From: Amanda Scholes on behalf of Planning.Responses
Sent: 05 February 2018 08:55
To: Planning Scanning
Subject: FW: Y/51/17/DOC - Yapton Free Church - 22815
Attachments: 201_A_Proposed Drainage Layout.pdf

PROJECT
Yapton Free Church,
Yapton

TITLE
Proposed Drainage
and Construction Details

PROJECT NO.
22815

201 A

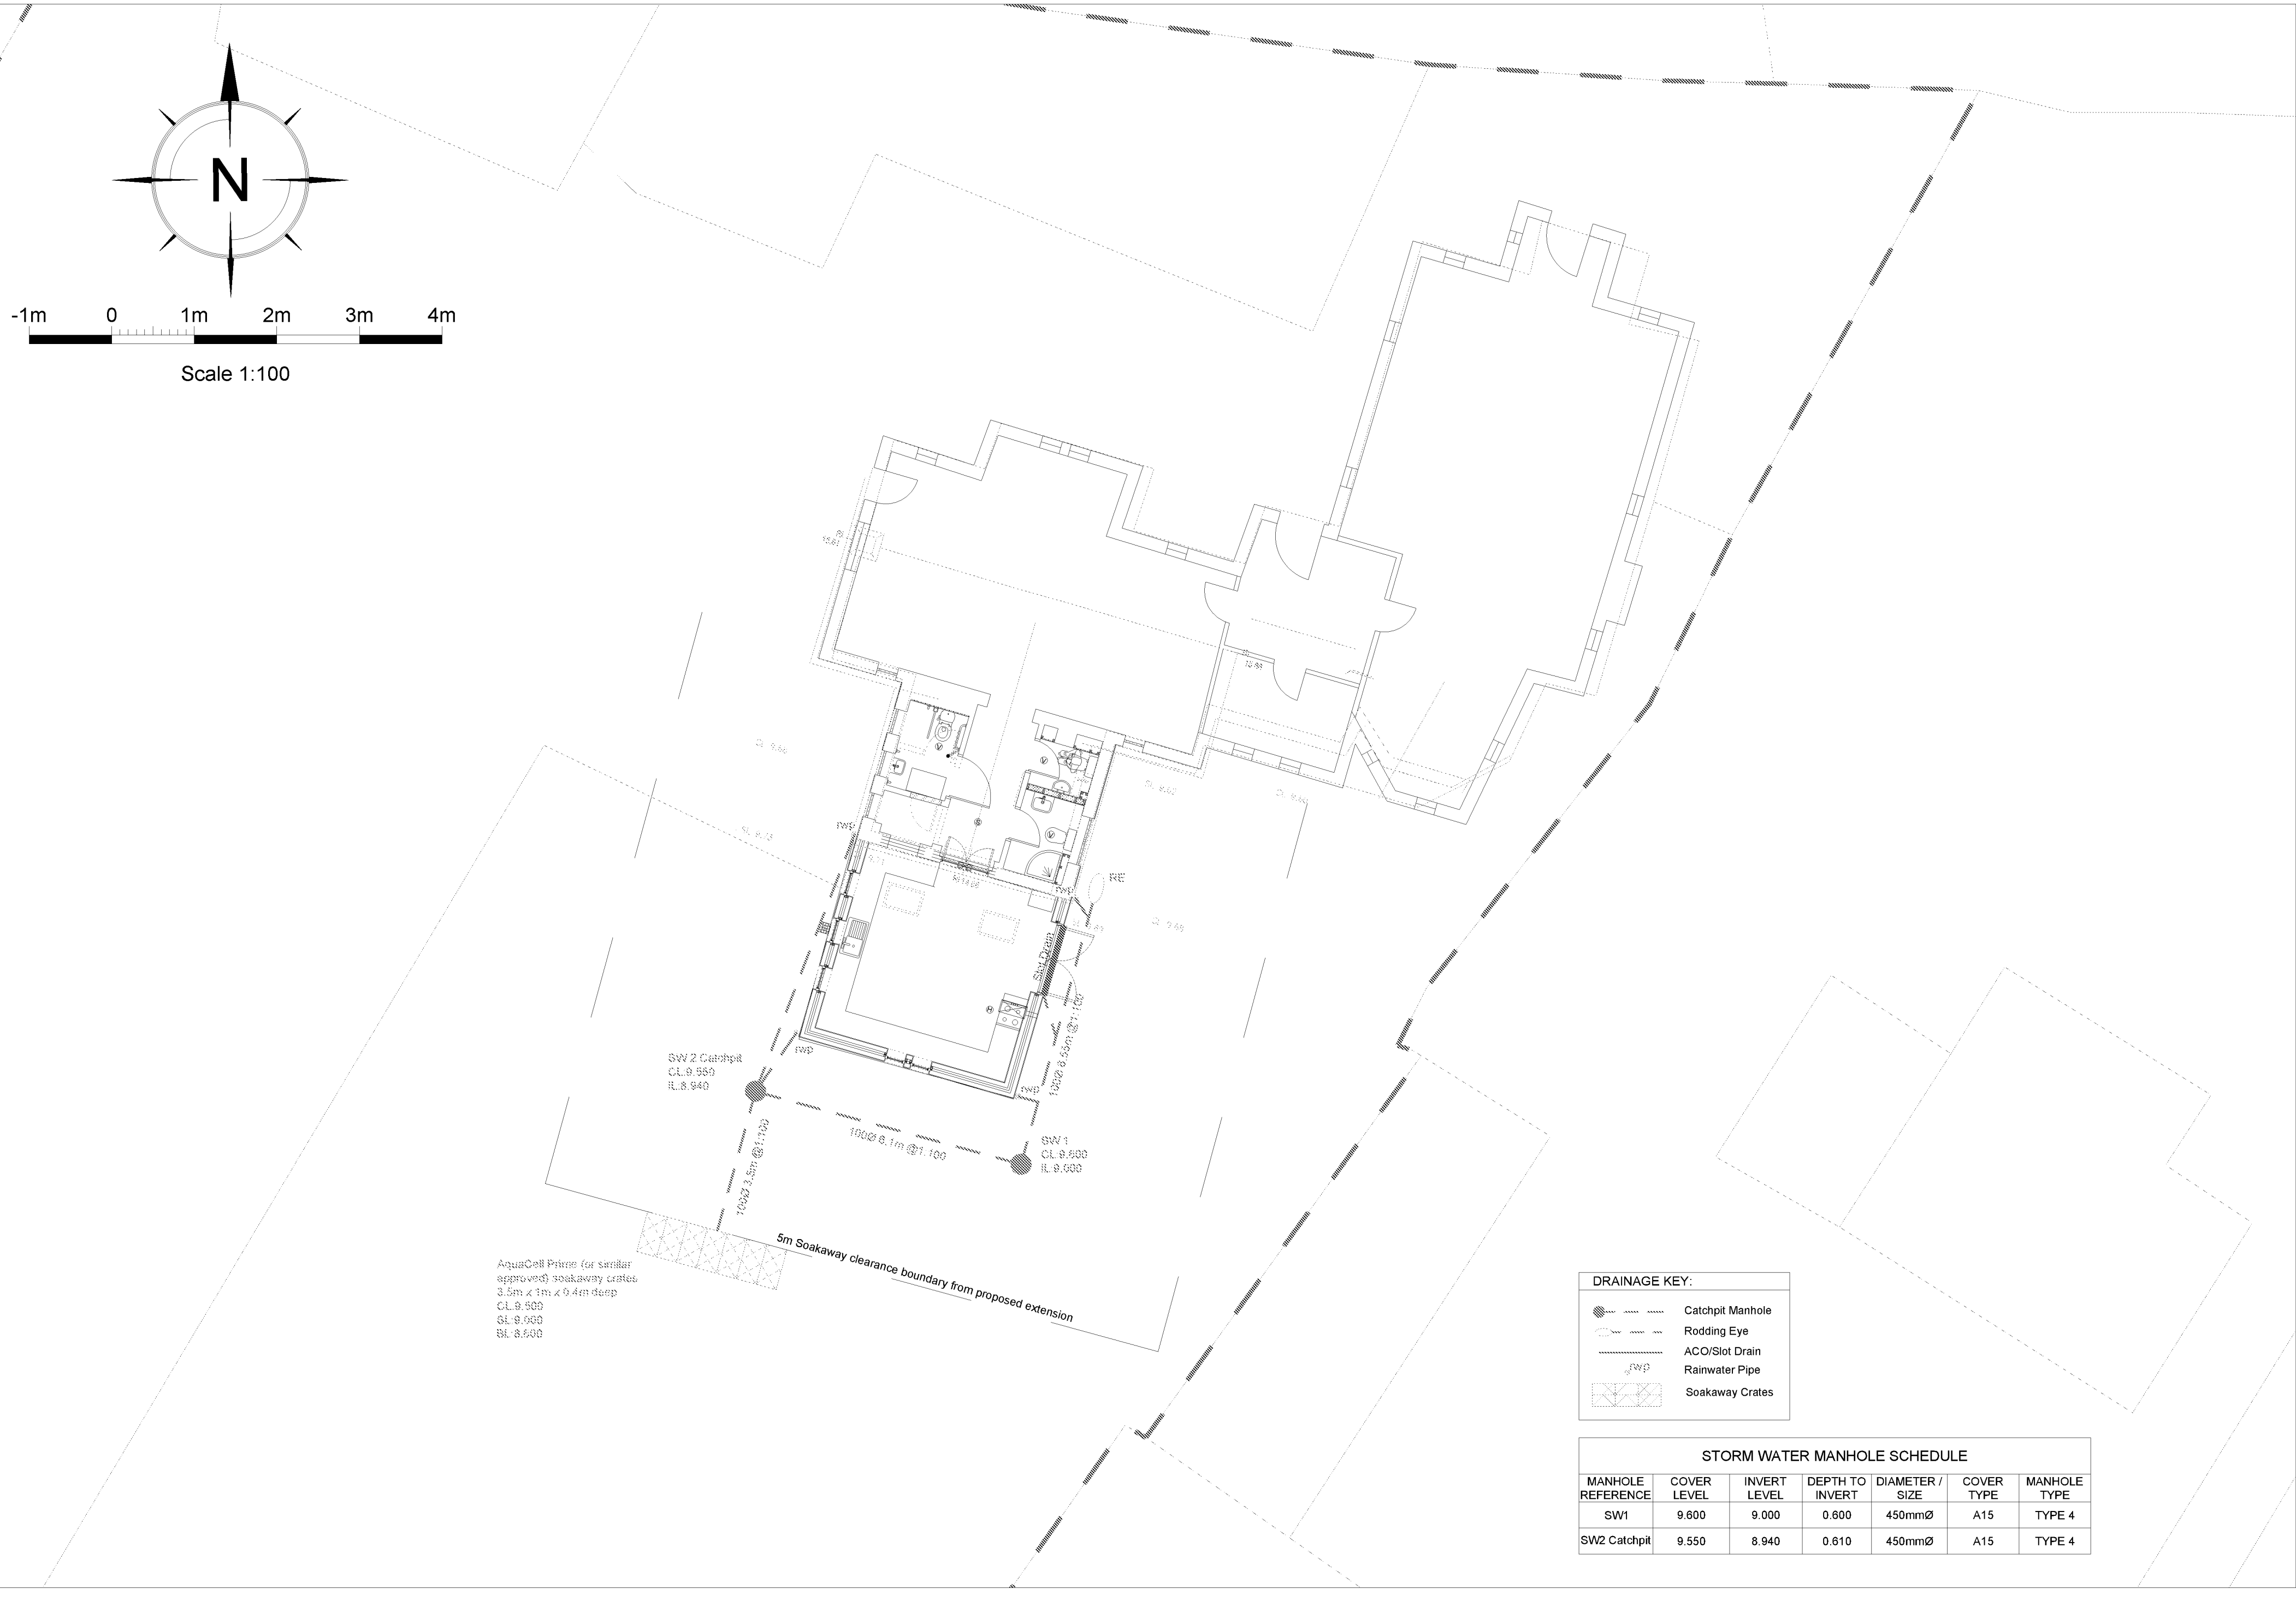
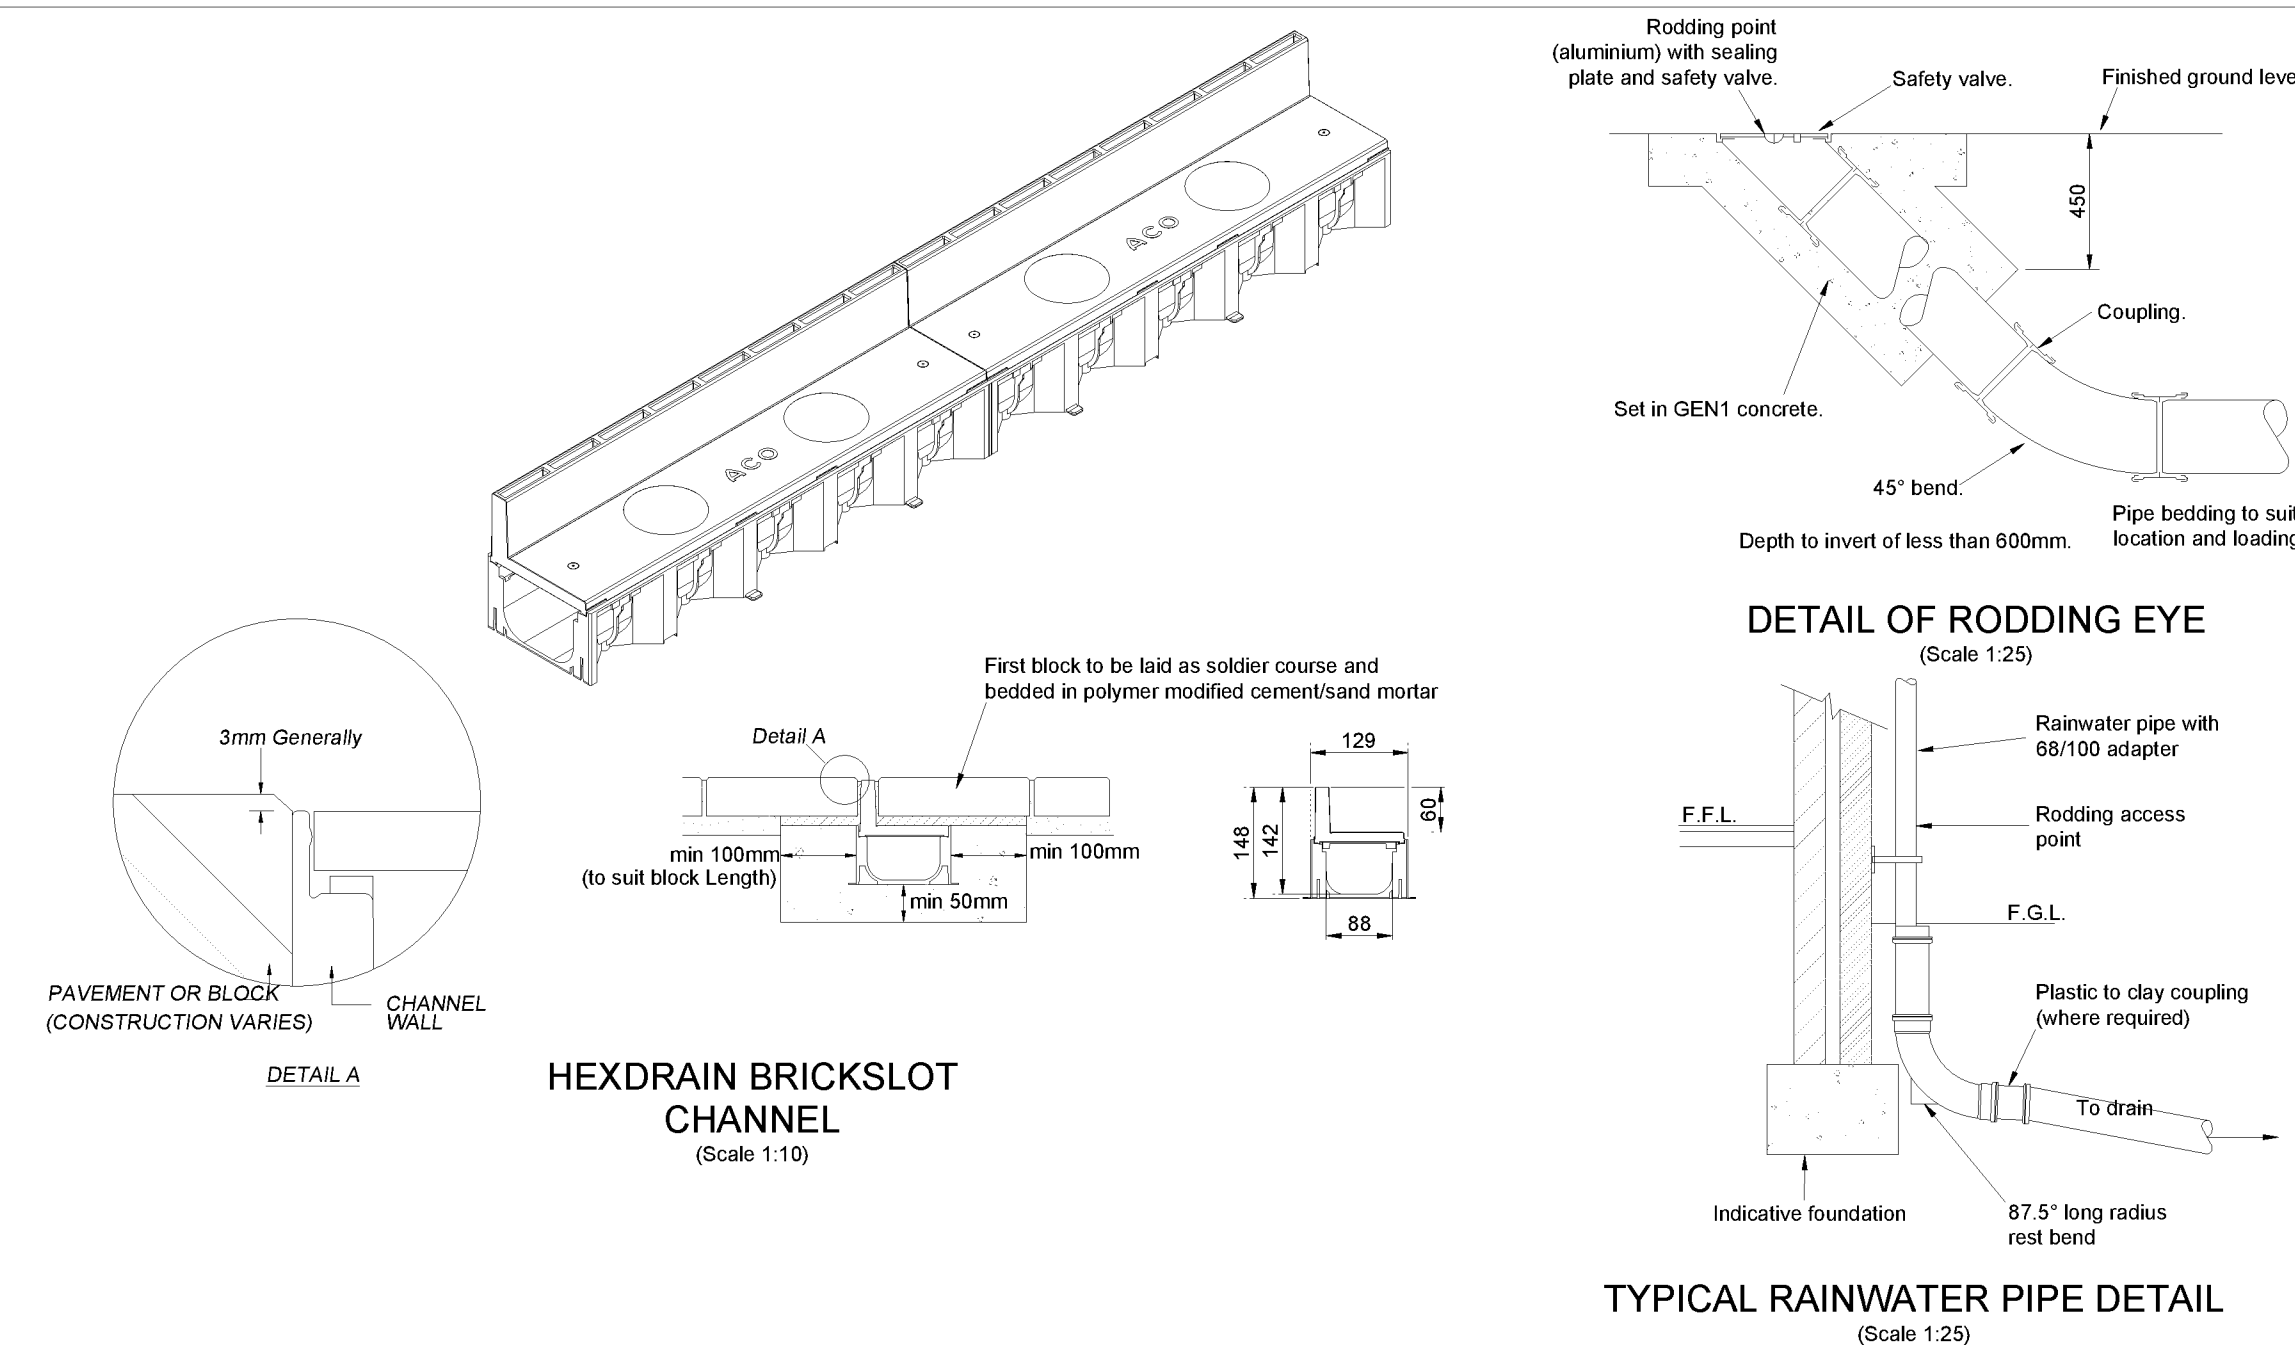
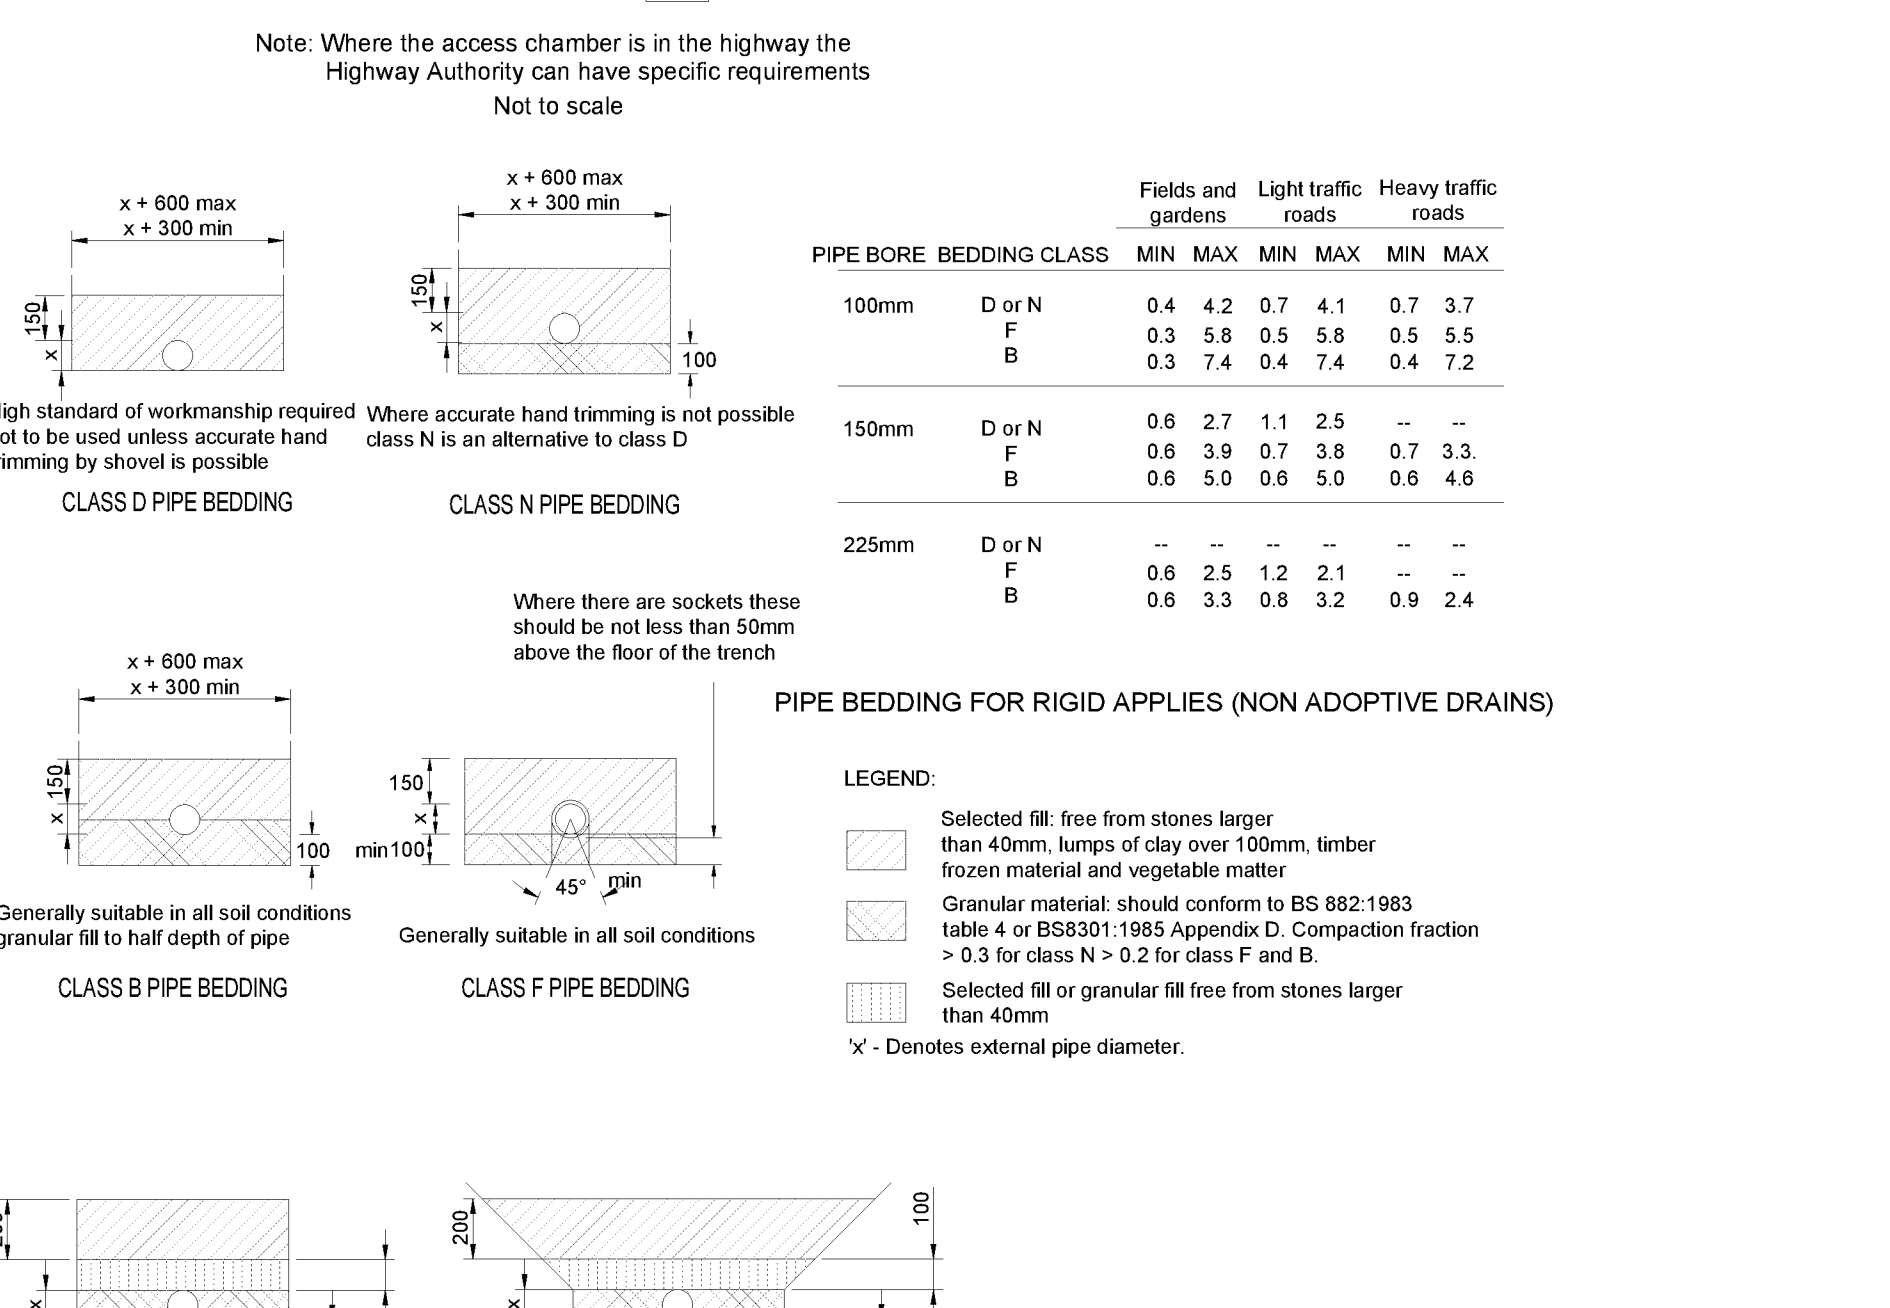
Condition can be discharged based upon the revised details, including drg no. 22815/201 Rev A, which I have enclosed.

Further to our telephone conversation regarding the percolation rate used for the calculations, please note that the percolation rate used is the same in both sets of calculations.

We have provided you with both Microdrainage calculation sheets and our internal spreadsheet extract demonstrating that the proposed system works.

Microdrainage method of inputting factor of safety is different as it requires one to be specified in the input separate to the percolation value.

Our simplified spreadsheet incorporates the factor of safety within the percolation rate hence the difference between the two printed versions.

Both sets of calculations demonstrate that the proposed drainage system (same size under both calculation sets) meet your requirements.

I now attach the revised MicroDrainage Calculation with the correct cover and invert levels together with the rainfall details as requested.

A 05.01.18 TZ Soakaway Size Revised SRM
